BC 3-5 REPLACING MIXING ARM MOTOR:

BC 3-5 REPLACING MIXING ARM MOTOR:

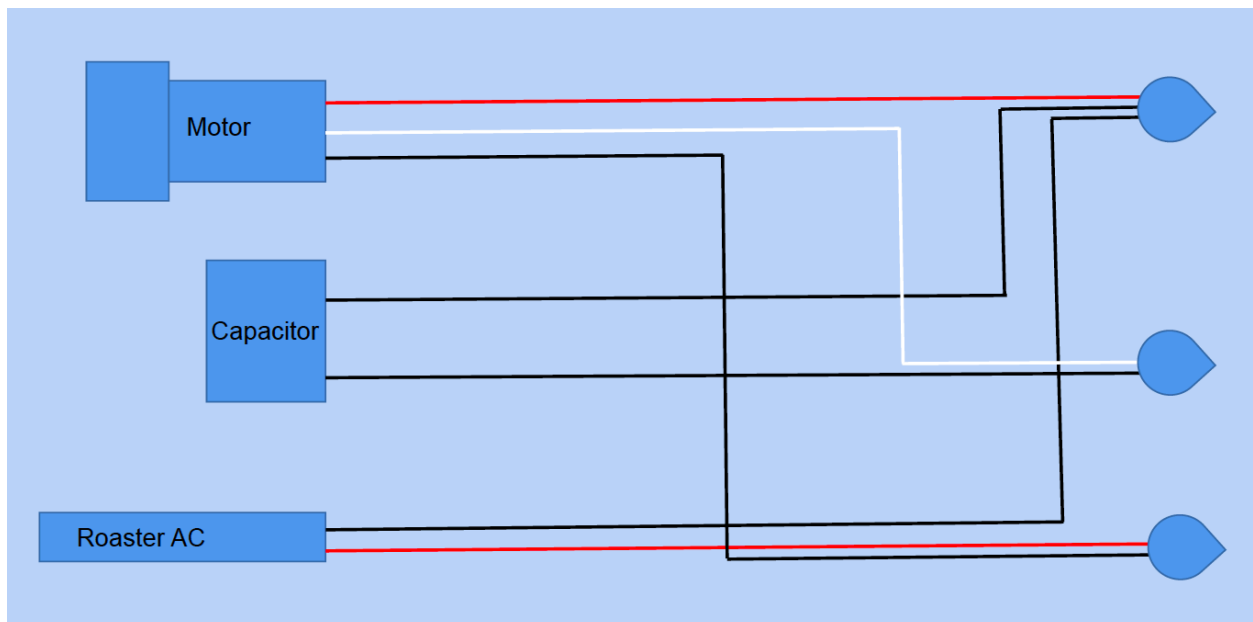
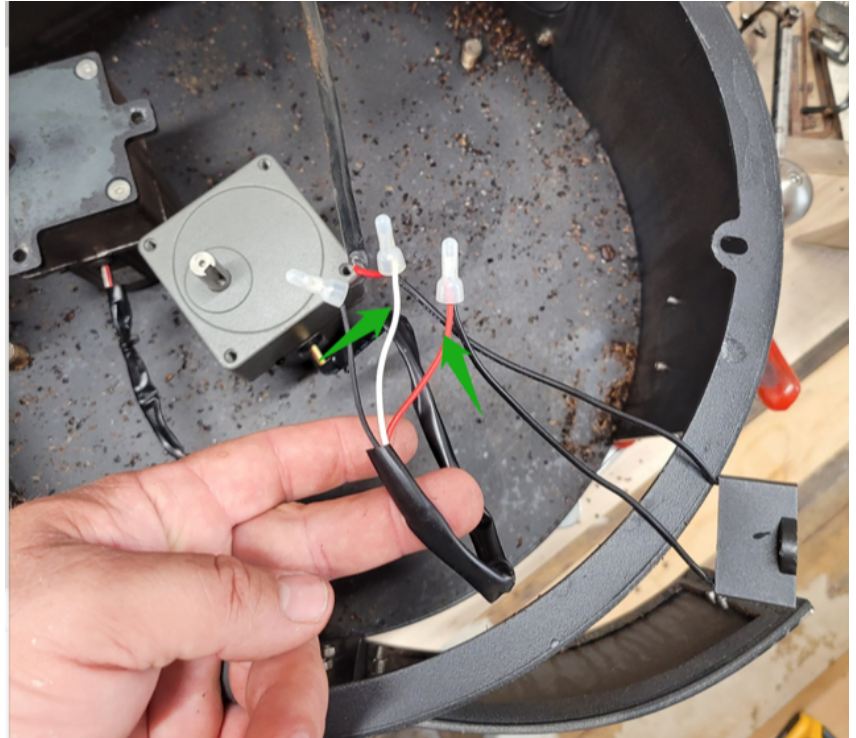
6. (8.3.21) THE MOTOR FACTORY CHANGED THE WIRING COLOR CODES ON THE MIXING MOTOR WITHOUT INFORMING THEIR CLIENTS.

THE RESULT IS THAT IF YOU WIRE THE COLORS EXACTLY AS BEFORE (SEEN IN ATTACHED PICTURE) THE MOTOR ON THE MIXING ARMS WILL GO IN REVERSE WHICH WILL NOT WORK PROPERLY.

SOLUTION: (SEE DRAWINGS ATTACHED)

AFTER REMOVING OLD MOTOR CHANGE OUT THE WIRES BETWEEN THE RED AND WHITE WIRES ON

RETEST BEFORE REASSEMBLY OF MACHINE: THEN AFTER ALL WIRES ARE CAPPED WITH WIRE NUTS OR TEMPORARILY WITH ELECTRICAL TAPE YOU CAN PLUS ROASTER INTO POWER AND TEST TO MAKE SURE UNIT RUNS IN
